IV. DRAFT EIR TEXT REVISIONS

Chapter IV presents specific changes to the text of the Draft EIR that are being made to clarify information in the Draft EIR, in response to comments received during the public review period or the direction of City staff. In no case do these revisions introduce “significant new information” as defined in *CEQA Guidelines* Section 15088.5, including new or more severe environmental impacts, new mitigation measures or alternatives that the project applicant declines to adopt, or information indicating that the Draft EIR is fundamentally inadequate. All revisions contained herein are minor in nature. Where revisions to the main text are called for, the page and paragraph are listed, followed by the associated revision. Added text is indicated with underlined text. Text deleted from the Draft EIR is shown in ~~strikeout~~. Page numbers correspond to the page numbers of the Draft EIR.

A. RESPONSE TO COMMENTS TEXT REVISIONS

FIGURE III-3
Revised

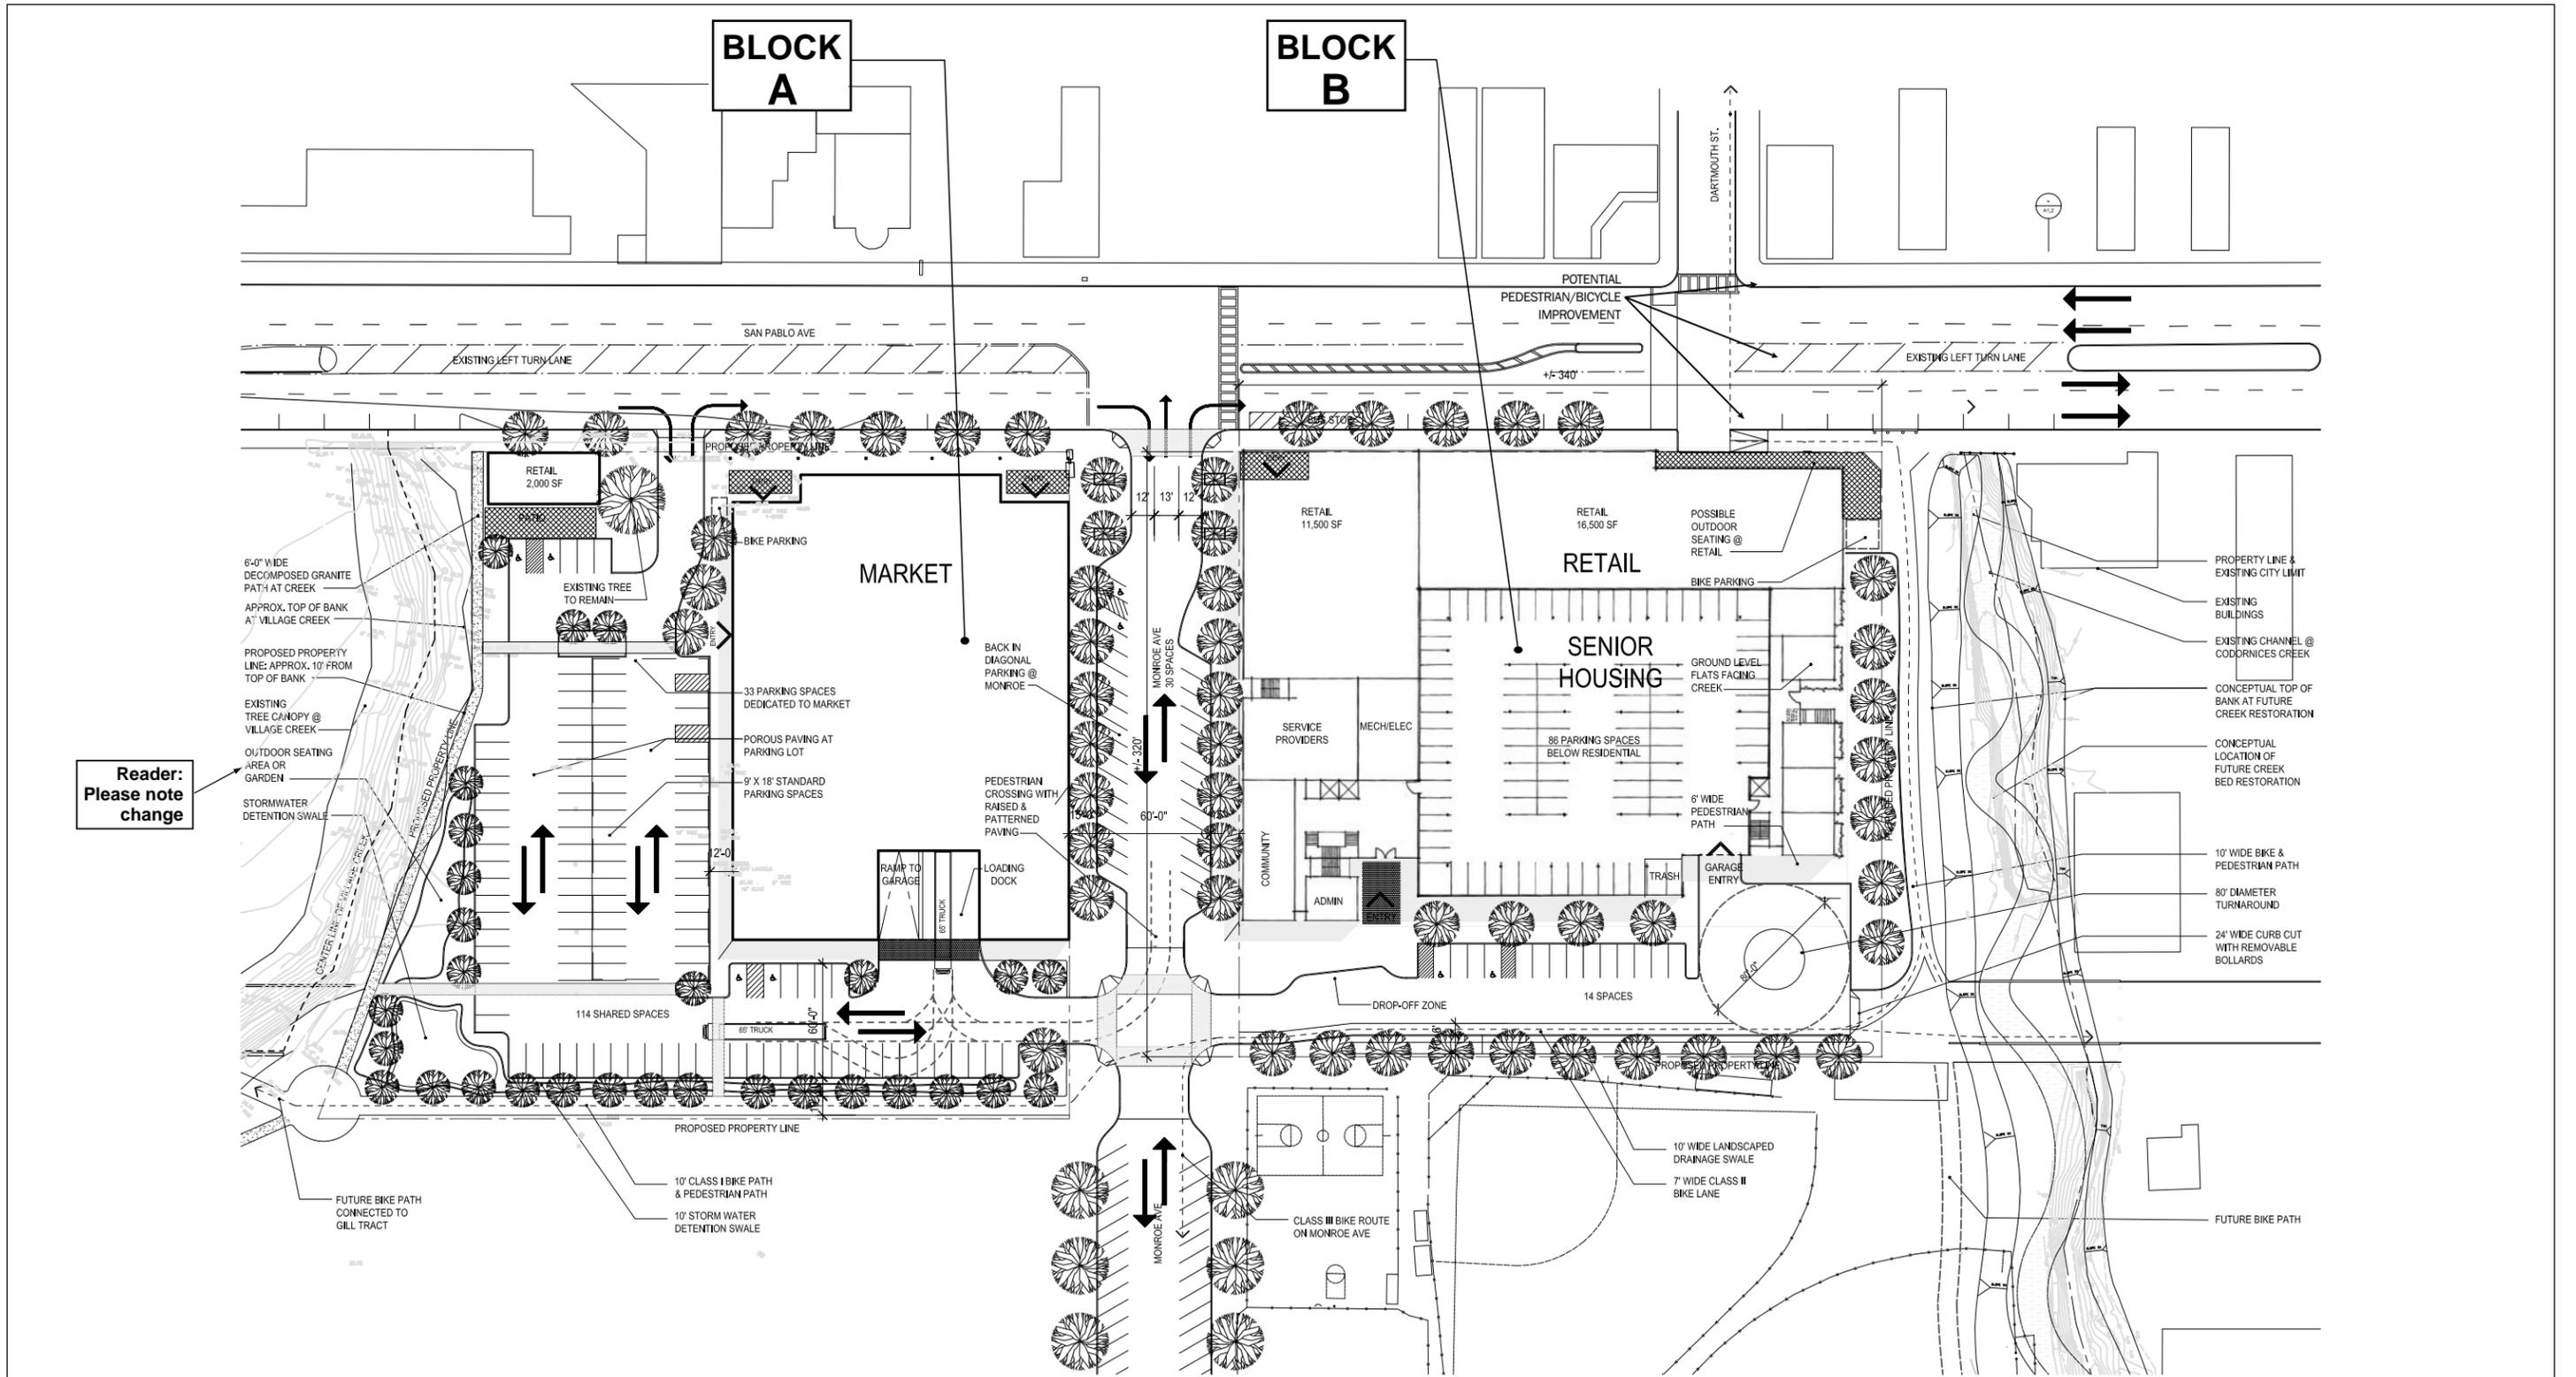
Figure III-3 (Draft EIR, p. 39) is hereby revised on the left-hand (northern) side of the figure to delete the word “community” and correct the conjunction “of” which should have said “or”. This very minor change in the graphic is consistent with the text of the Project Description in the Draft EIR. A revised version of Figure III-3 is provided on the following page.
